ADDENDUM NO. 2

Rochester City School District

Dr. Walter Cooper, School #10

February 28th, 2018

AD2-E012

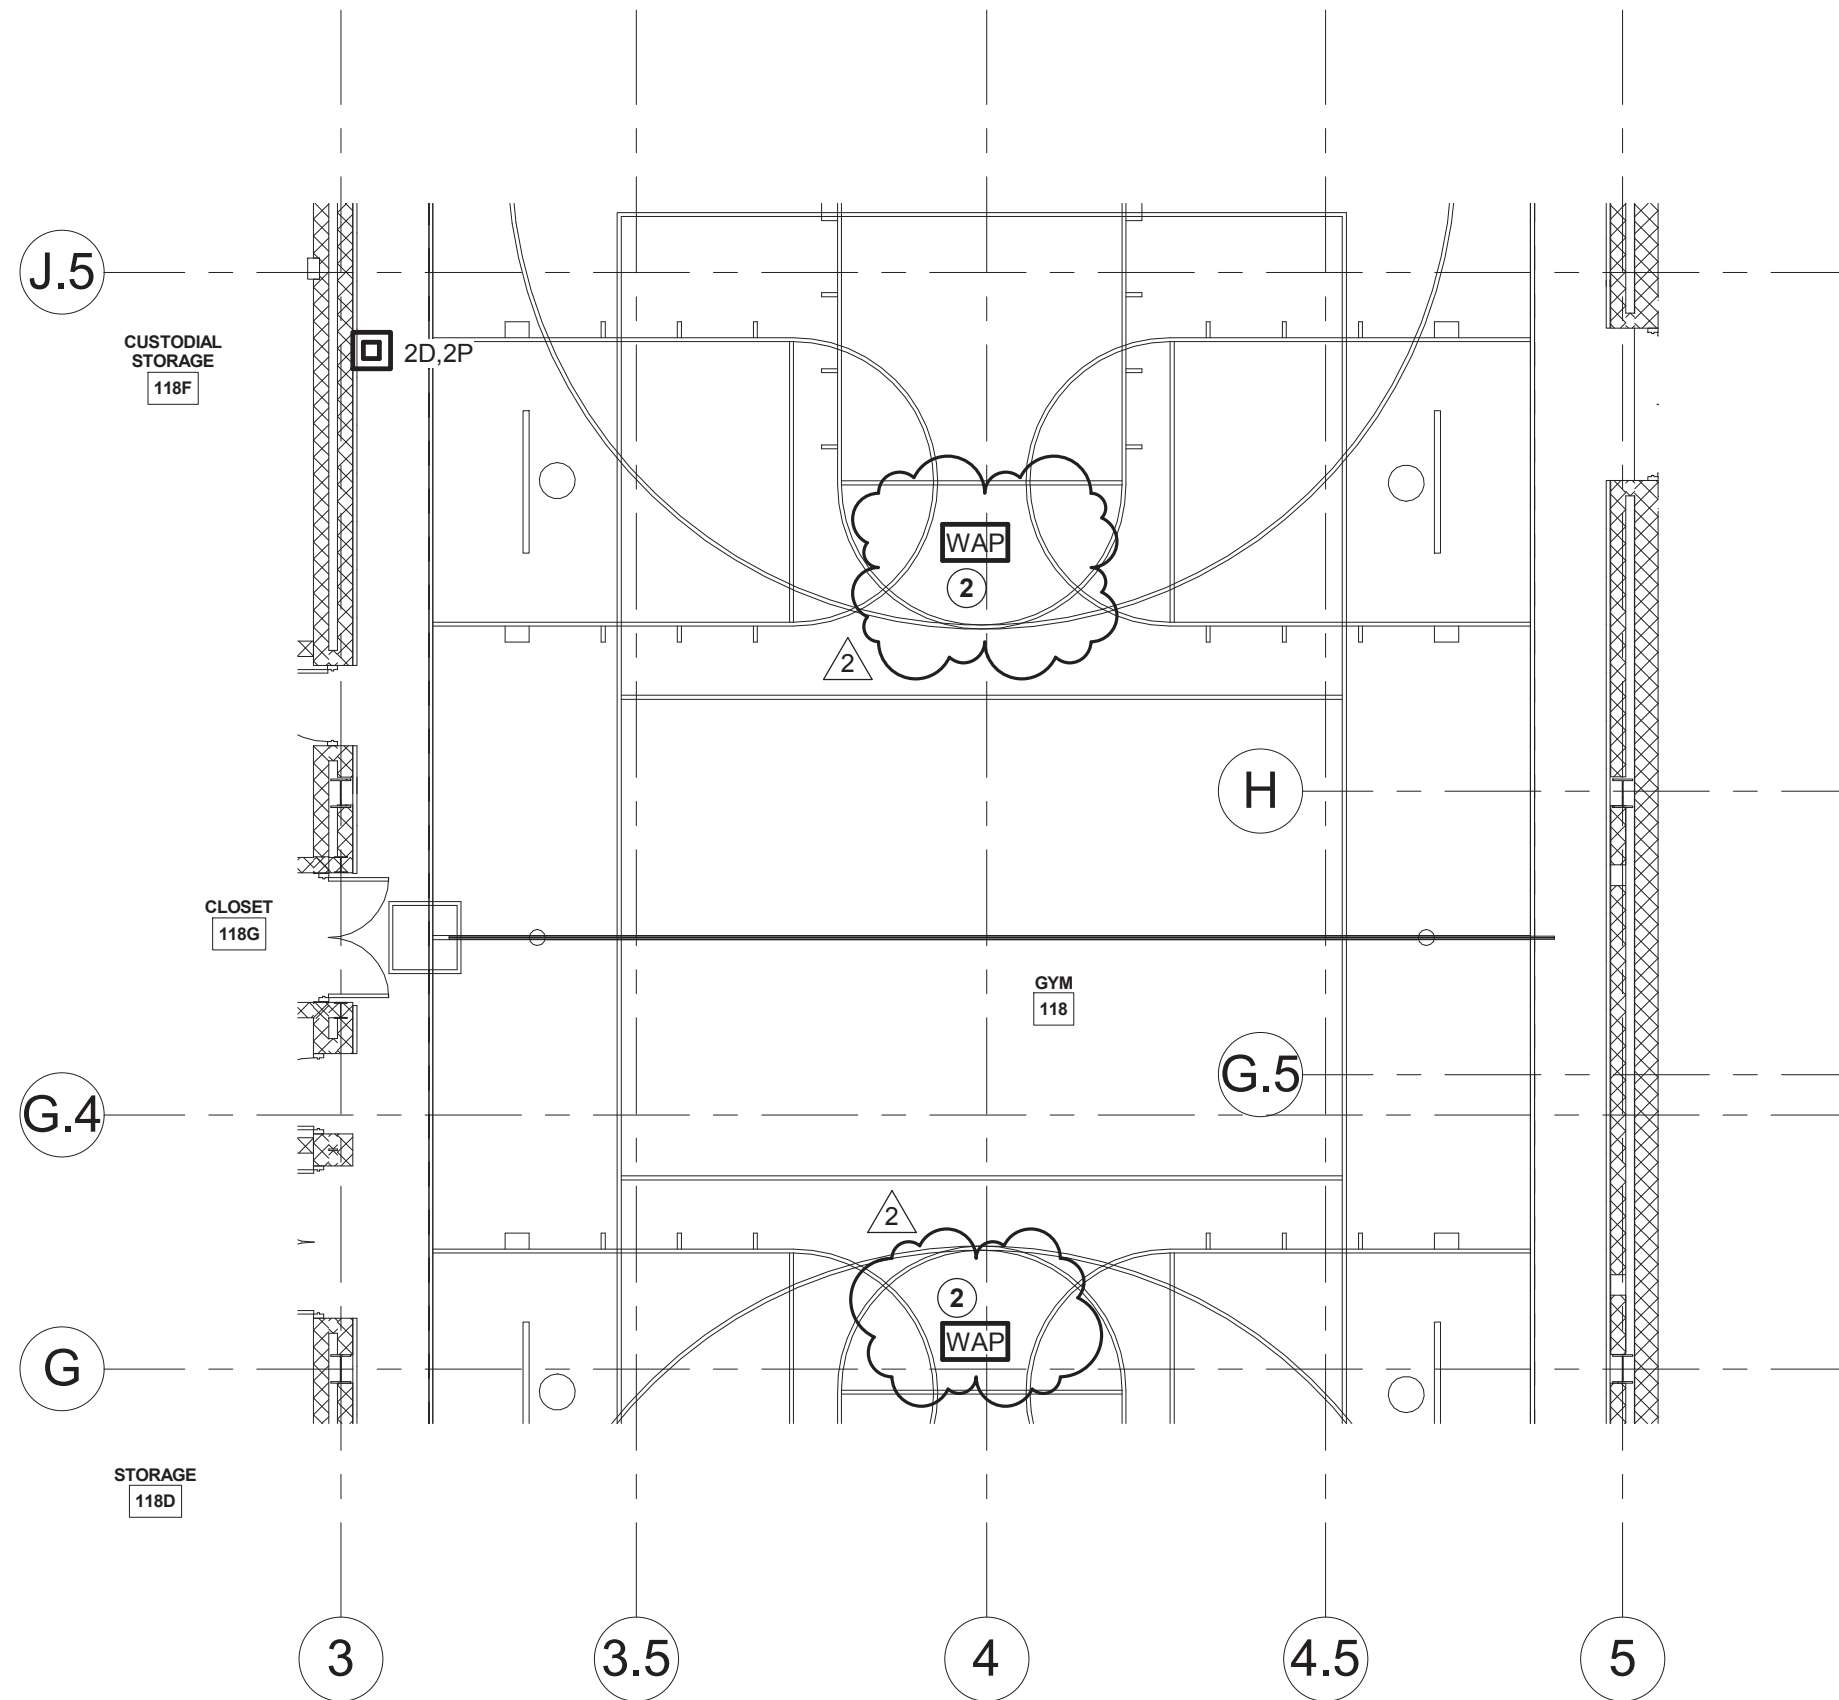
Item AD2-83 **ADD** attached sketch "AD2-E012 - PARTIAL FIRST FLOOR PLAN - DWT," adding wireless access points.

AD2-E013

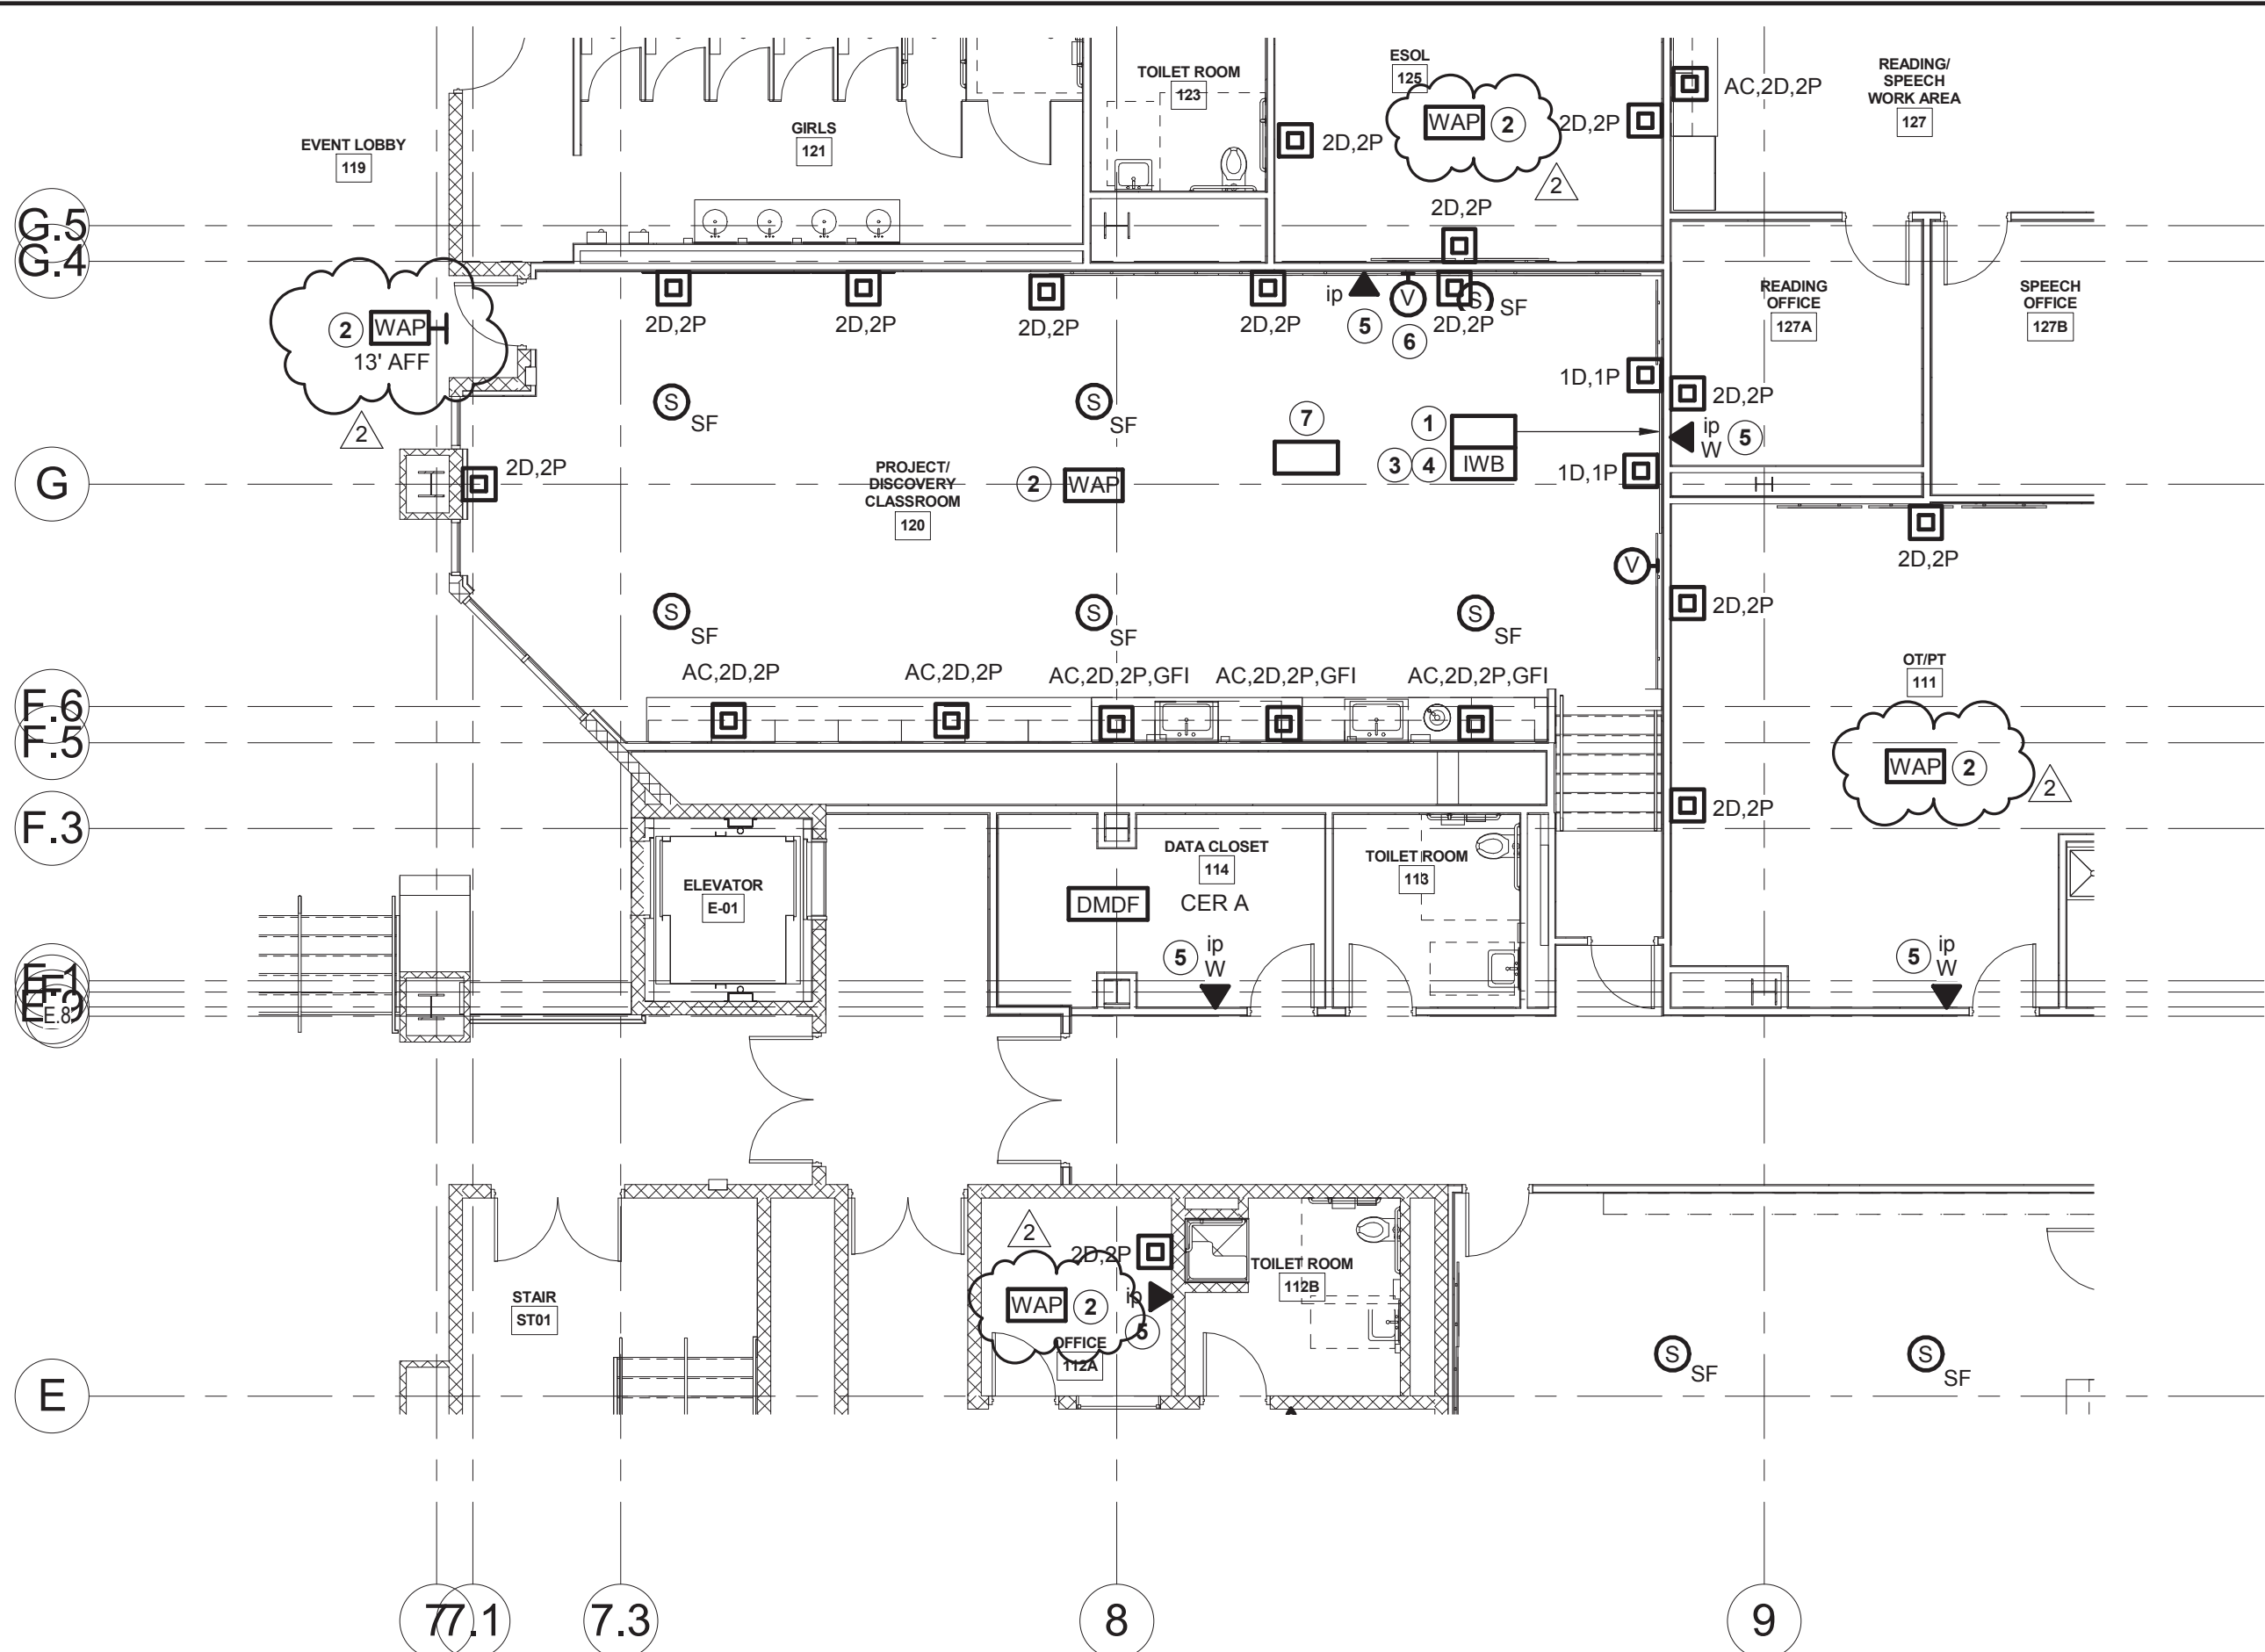
Item AD2-84 **ADD** attached sketch "AD2-E013 - PARTIAL FIRST FLOOR PLAN - DWT," adding wireless access points.

AD2-E014

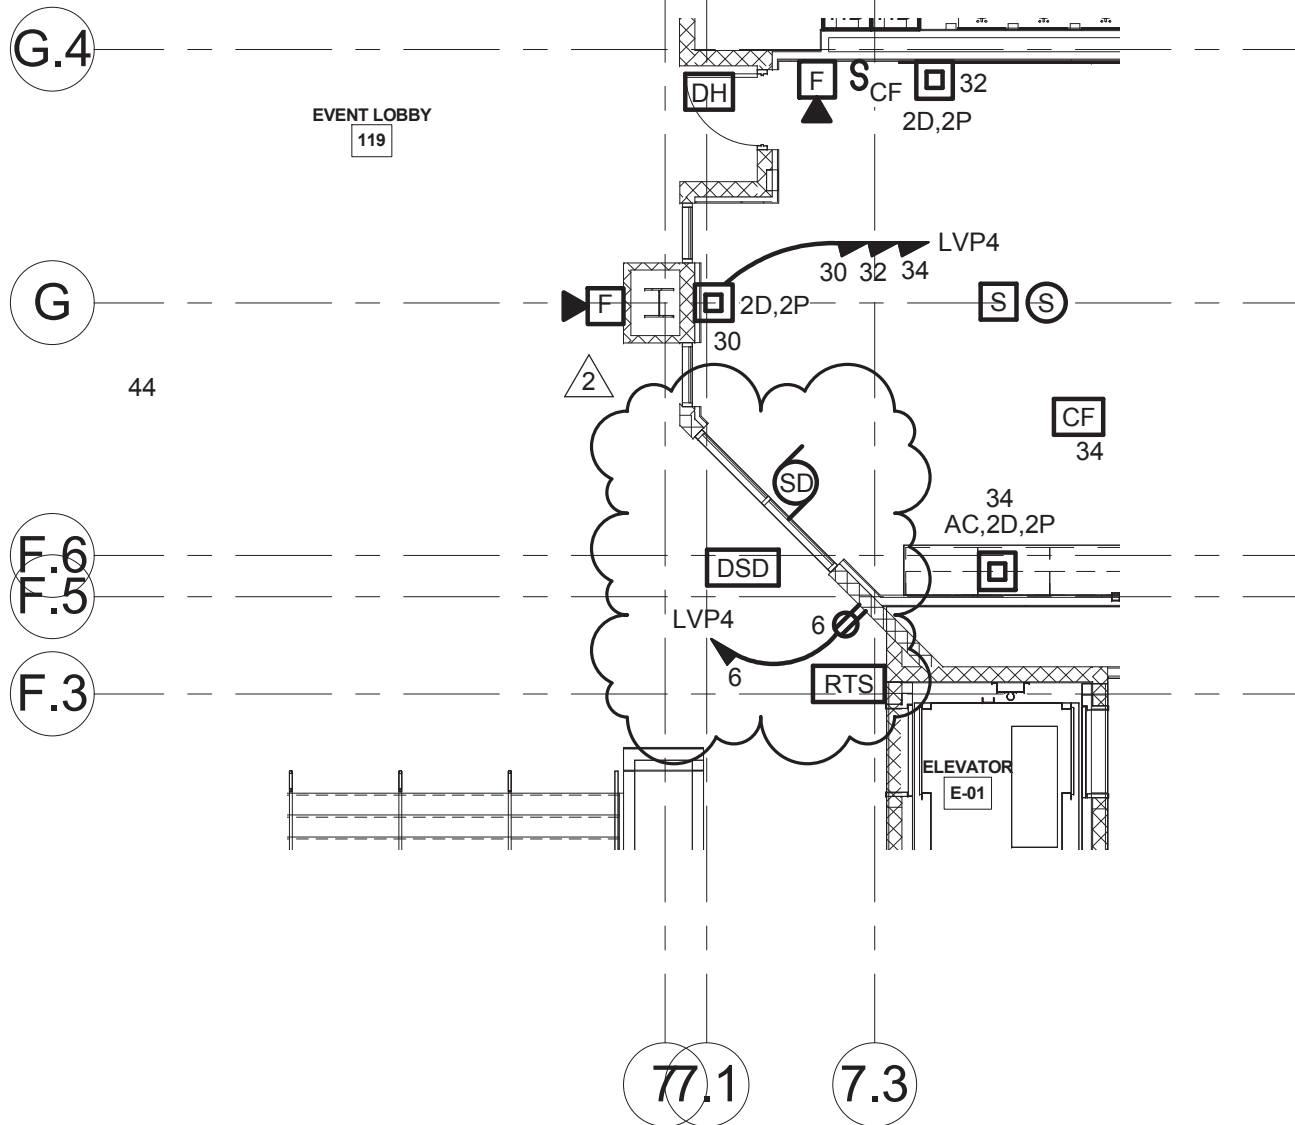
Item AD2-48 **ADD** attached sketch "AD2-E014 - PARTIAL FIRST FLOOR PLAN - POWER AND SS," adding a smoke damper, duct smoke detector, and remote test station.
